WT Repair Rework

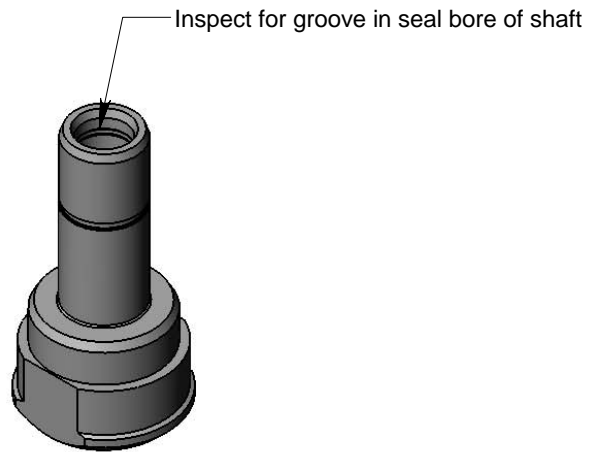
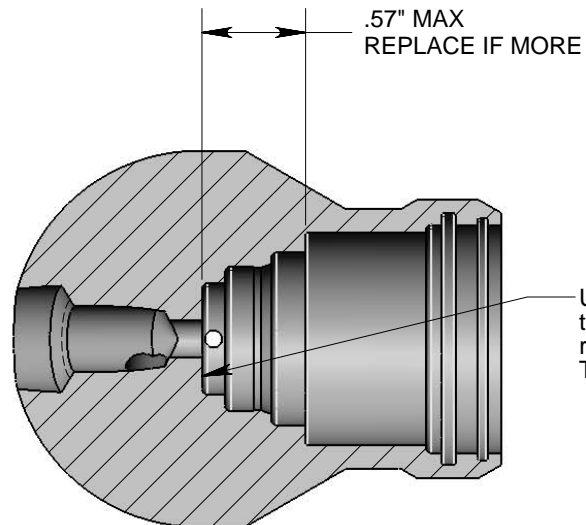
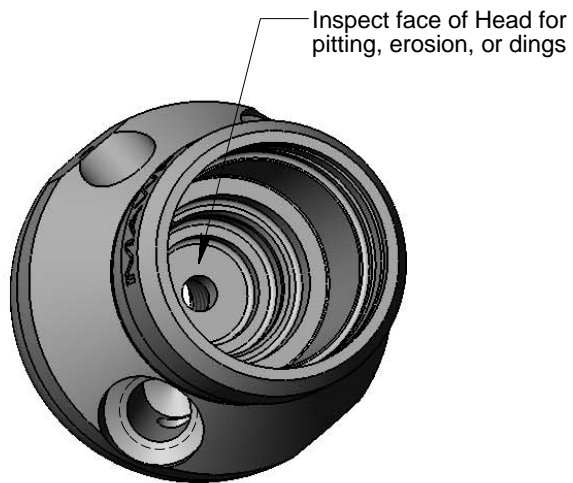
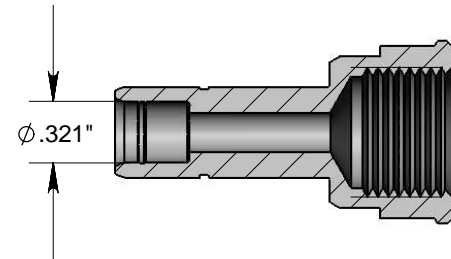
Polish bore of shaft until groove is removed; if bore is larger than $\phi .321$ ", recommend replacing shaft. If larger than $\phi .325$ ", replace shaft. There may be some pitting in bore of shaft; some small pits are okay and do not have to be removed by polishing.

Using a flat-faced bar polish this face to 32 finish or better; enough to remove all pitting or other damage. Typically .020" or less.
